Contract #: 04-0120F4Cty: SF/ALA Rte: 80 PM: 13.2/13.9File #: 69.25B**QUALITY ASSURANCE -- NON-CONFORMANCE REPORT****Location:** Changxing Island, Shanghai, PRC**Report No:** NCR-000361**Prime Contractor:** American Bridge/Fluor Enterprises, a JV**Date:** 14-Jul-2009**Submitting Contractor:** Zhenhua Port Machinery Company, Ltd (ZPMC), Changxing Island**NCR #:** ZPMC-0335**Type of problem:**

**Reference Description:** Oversized Holes Drilled in LD**Description of Non-Conformance:**

**Job Name:** SAS Superstructure  
**Document No:** 05.03.06-000314

Subject: Fabrication Issue: Oversized Holes in Longitudinal Shear PL at SEG2AE and SEG2BE Splice	
References: SEG10C	
Response required by: <u>2009-7-23</u> (date)	Response affects critical path activity? <input checked="" type="checkbox"/> YES <input type="checkbox"/> NO

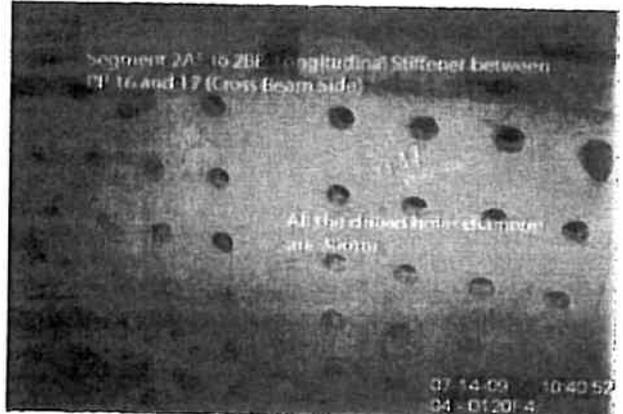
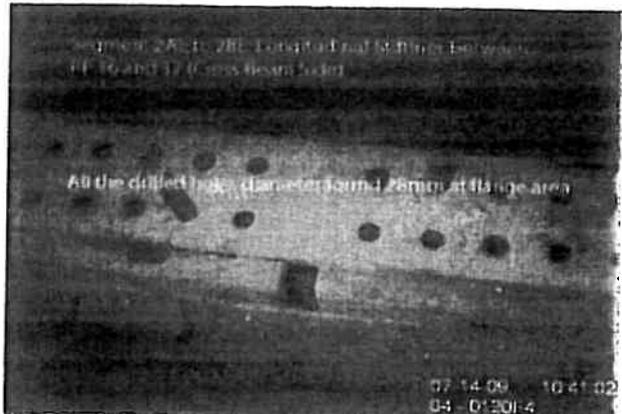
Caltrans Quality Assurance (QA) Inspector observed oversized holes drilled at the Longitudinal Stiffener (LD) for Segment 2AE to 2BE, between PP 16 and 17 (Cross Beam Side) in the web area. Holes drilled for M24 bolts are generally drilled with a 26mm diameter. The holes at this area were measured as being 28mm and 30mm diameter bolt holes.

For further information, please see the attached pictures below.

RFI No.: RFI-ZPM-000692R00 Submitted by: Lu Jun Page(s): 1  
 RFI Date: 2009-7-16 Contact Name: Sun Weidong Phone No. +86-21-51907428

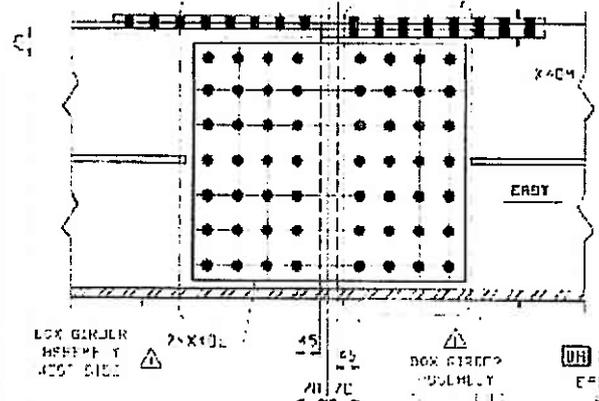
During fabrication, it is found all the holes in longitudinal shear PL at SEG2AE and SEG2BE splice are mistakenly drilled into 30mm while per shop drawings it shall be 27mm. There are 112 mistakenly oversized holes in total and edge distance is 45mm. ZPMC proposes to,

1. Leave the oversized holes "as built" and use M24 HSB on them. Then minimum edge distance ( $24 \times 1.75 = 42\text{mm}$ ) can be kept.
2. Leave the oversized holes "as built" and use M27 HSB on them.

ZPMC's proposal to use 27mm bolts in lieu of 24mm bolts is acceptable.

For this type of substitution it is also critical to check the center to center spacing on the bolts in question. In this instance the center to center spacing is 90mm and is greater than  $3 \times \text{DIA}$  and therefore acceptable.

ZPMC should revise shop drawing to indicate the location of this change.
